# TASPEN RIDGE - STOCKP COLORADO SPRINGS, COLORADO DING & EROSION CONTROL PLANS

EPC's EDARP File Number: CDR2312

|  | TRAILS AT ASPEN RIDGE - STOCKPILE                          |                  |                          |            |                       |                    |                     |  |
| PRELIMINARY  | CONSTRUCTION DRAWINGS<br>GRADING AND EROSION CONTROL PLANS |                  |                          |            |                       |                    |                     |  |

|  | <ul> <li><u>BENCHMARK</u></li> <li>COLORADO SPRINGS UTILITIES (FIMS) MONUMENT F206</li> <li>A BERNTSEN TOP SECURITY MONUMENT SYSTEM WITH A 3.5-INCH DIAMETER ALUMINUM CAP IN</li> </ul>  |               | SEAL  | TRAILS AT ASPEN RIDGE - STOCKPILE  |
|--|--|---------------|---|--|
|  | CORNER OF SAID SECTION 9 (3 ¼" AULM. CAP PLS 10377)  | <b>Matrix</b> | FOR AND ON BEHALF OF<br>MATRIX DESIGN GROUP, INC.<br>PROJECT No. 23.886.078 | DESIGNED BY: NMS SCALE DATE ISSUED: MAY 2023 DRAWING No.<br>DRAWN BY: KGI HORIZ. N/A<br>CHECKED BY: NMS VERT. N/A SHEET 5 OF 5 ECNO2 |

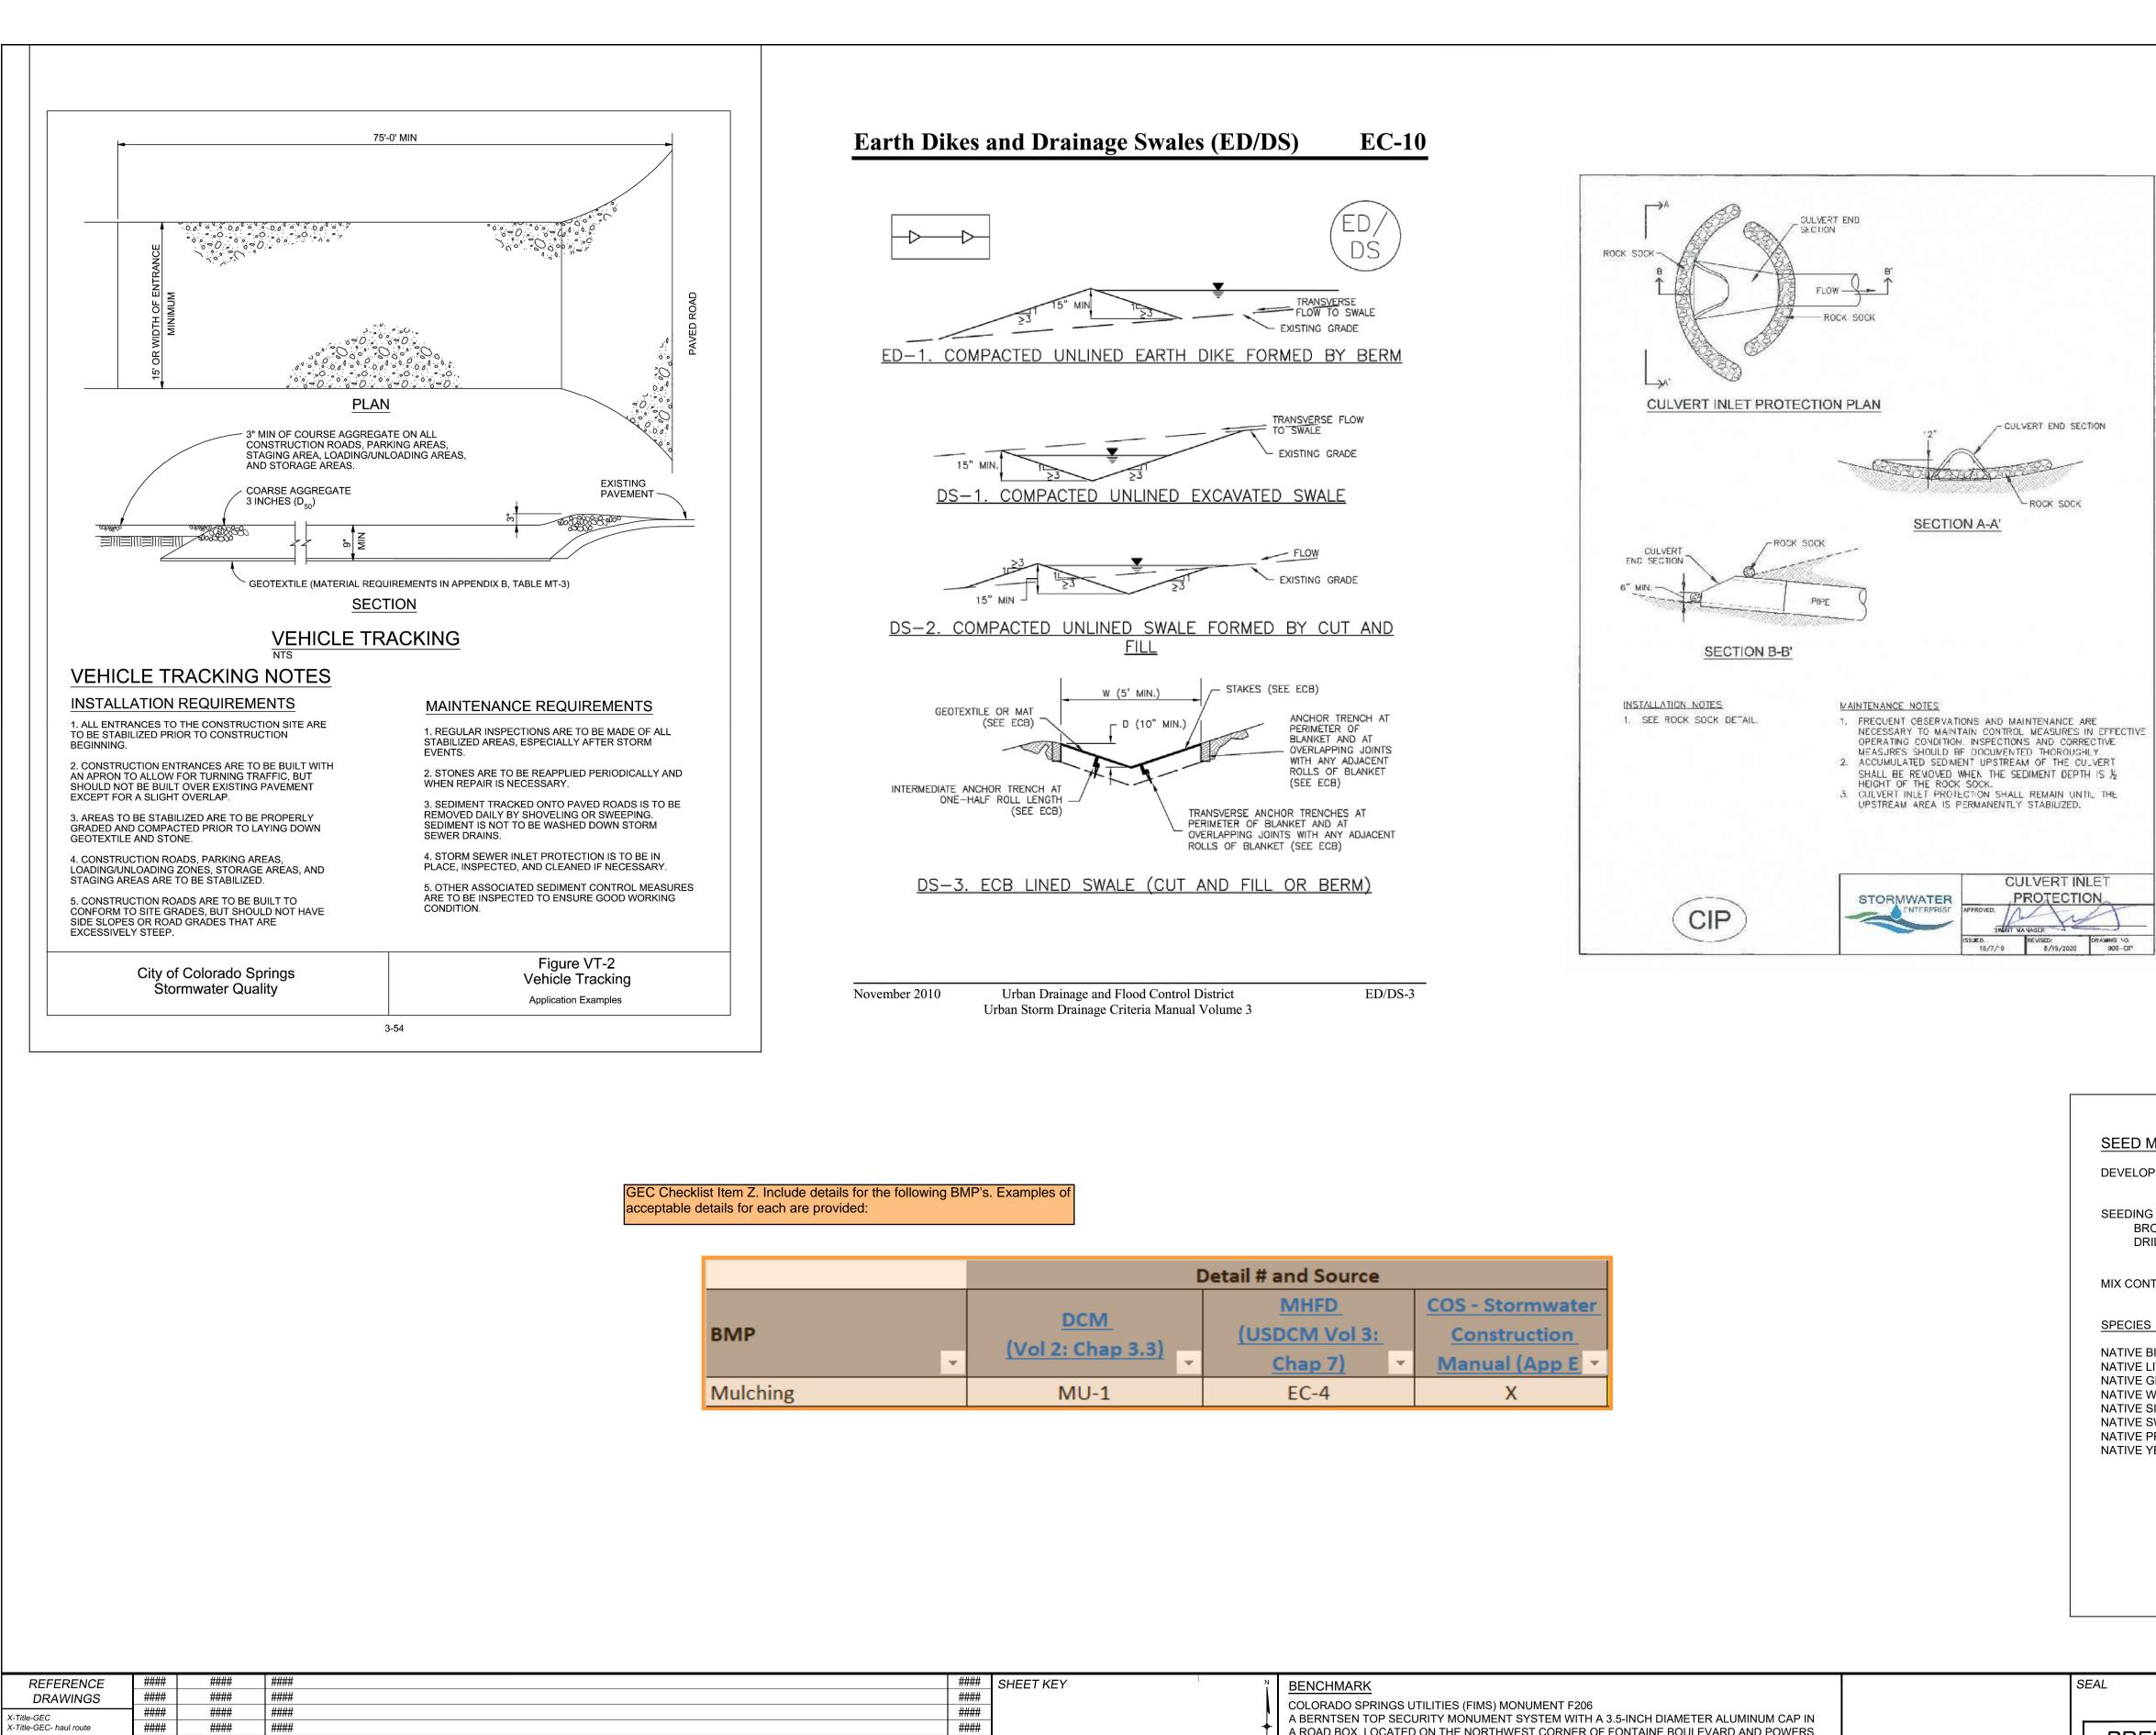
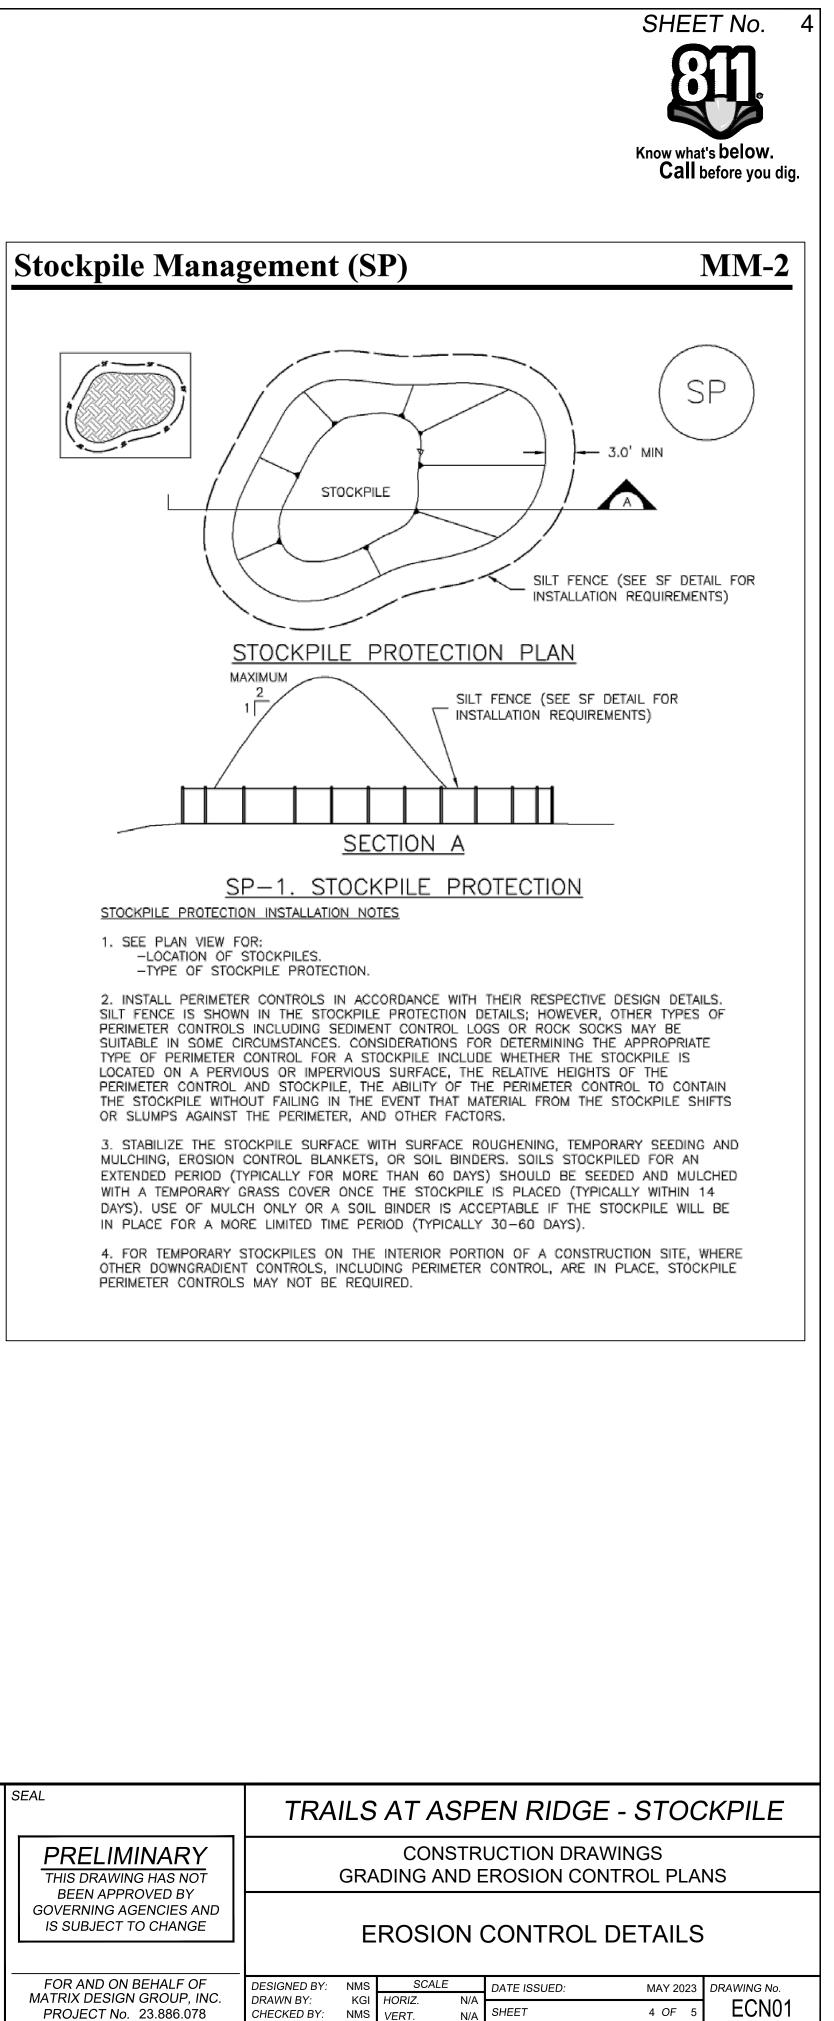
GEC Checklist Item Z. Include details for the following BMP's. Examples of acceptable details for each are provided:
